MEMO

To:	Box Real Estate Development Attn: Russell Pearson	
From:	Tom Fulton, Vice President Shannon Jeffries, PE, PTOE	
RE:	New Longview Development – Lot 44 Trip Generation Comparison	
Date:	March 11 th , 2024	
Olsson Project #:	023-07096

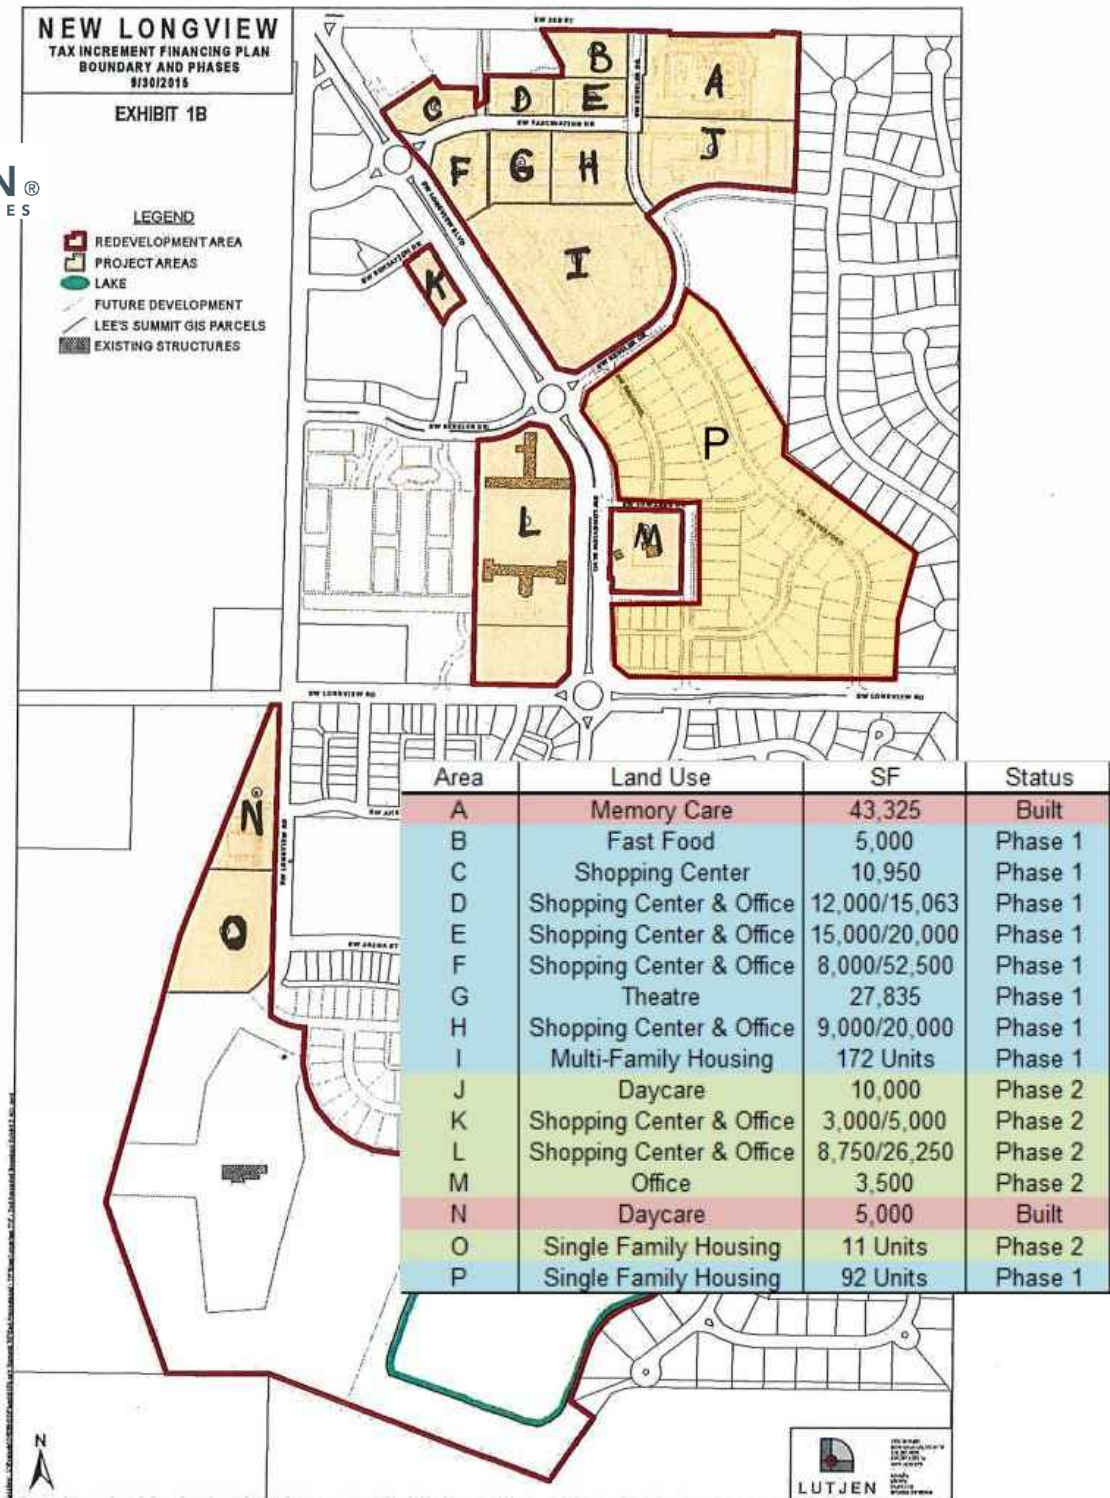
Currently, sidewalk is located along the west side of lot 44 adjacent to Longview Boulevard. A pedestrian ramp is provided in the southeast quadrant of the property with no connectivity to sidewalk. The site plan illustrates construction of new sidewalk along the north side of Fascination Drive providing connectivity from the existing pedestrian ramp to existing sidewalk located along Longview Boulevard. Sidewalk connections are proposed from Longview Boulevard and Fascination Boulevard internally to the site. A sidewalk connection to existing sidewalk located along the east side of the private road is not indicated; access to the existing sidewalk network is recommended.

No new access is proposed from public streets; access to the site will be provided along an existing private drive as well as a shared access with adjacent development. Planned sidewalk improvements will improve pedestrian connectivity within the vicinity of the site. A sidewalk connection from the northeast quadrant of the site connecting to existing sidewalk along the east side of the private road should be provided.
